September 6, 2013

Re: Cimarron Environmental Response Trust
Addendum to Hydrogeologic Pilot Test Report and Pneumatic Slug Test Memo

ATTACHMENT 3
Revised BA#1 Slug Test Solutions

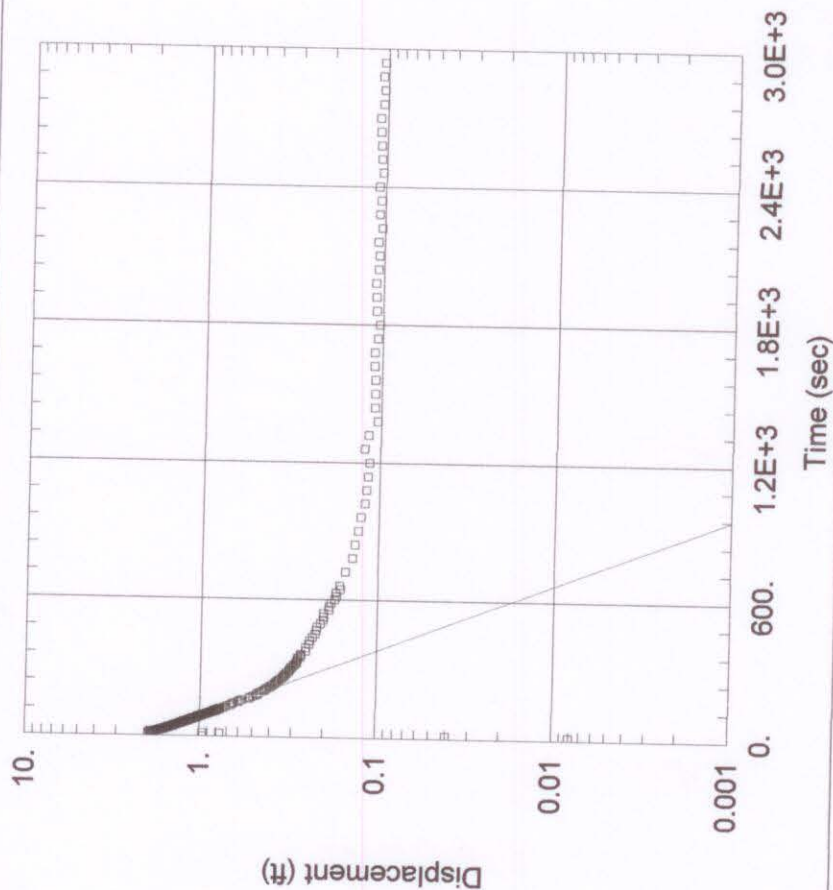
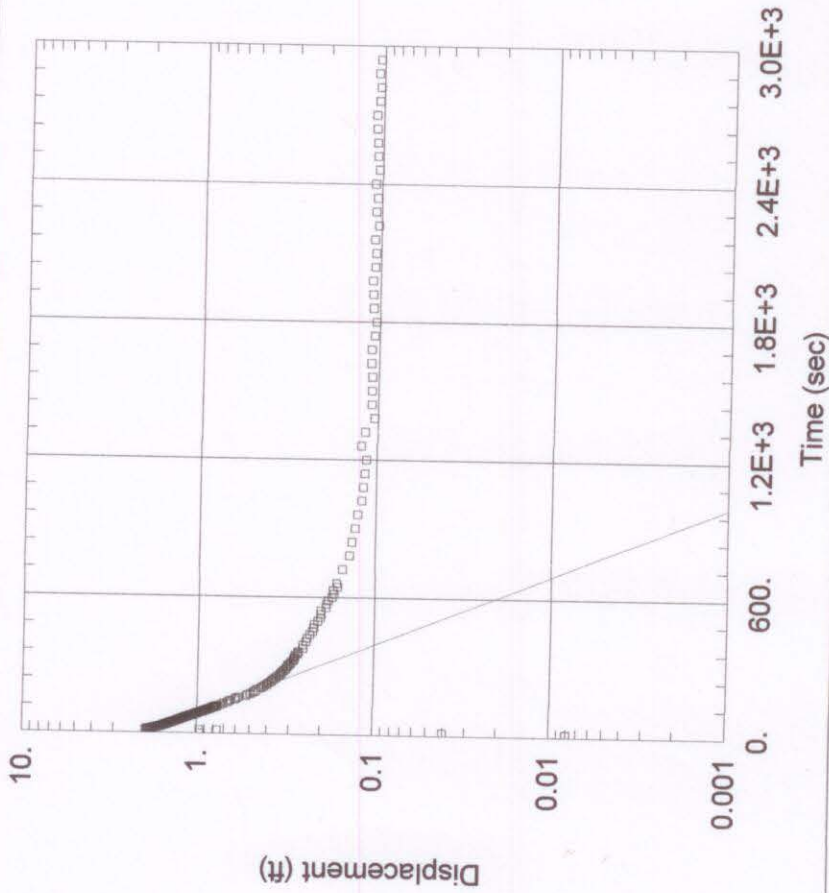
DEQ Comment: *Slug Test results for BA1 on page 5-4: The hydraulic conductivities (K) in the Table presented on page 5-4 do not seem to match with the AQTESOLV output (i.e., the graphs in Appendix C). Also the input data for the graphs, both well name and technical information about the well (such as saturated thickness, initial displacement, total well penetration depth, casing radius, well radius, static water column height, or screen length) do not seem to match with the respective well data in Tables C1-C14. This may be a reason for some of the unexpected results of low K where a high K was expected. Another reason may be using later times for the straight line portion of the graph instead of using early times for the straight line plot. Suggest placing the AQTESLV Output in the same order as the Tables and Figures in Appendix C.*

EMP Response: The BA1 slug test K values displayed on page 5-4 were erroneous as a result of entry error. A review of the AQTESOLV solutions showed that the project information was incorrect for all wells except TMW-5; however the solution input data were correct with the exception of the screen length. Although the screen length has little to no effect on the solutions, the screen lengths were corrected and the K values were recalculated using AQTESOLV. The K values for all seven BA1 wells are presented in Attachment 2. The AQTESOLV solutions for each well are presented in Attachment 3. With the exception of well 02W39, EPM does not concur with the use of the earlier data for straight line curve fitting. All of the wells tested except for 02W13 display the double straight line effect described by Bouwer (1989). The first straight line (earlier times) is steeper, indicating a higher K value, and is most likely caused by the draining of the filter pack into the well. Once the water level in the filter pack is equal to the water level in the well the second straight line is formed which demonstrates the K value of the

aquifer. Although the plot of the data from 02W39 also resembles the double straight line effect the straight line fit to the early time data is shallow enough to be reflective of the aquifer.
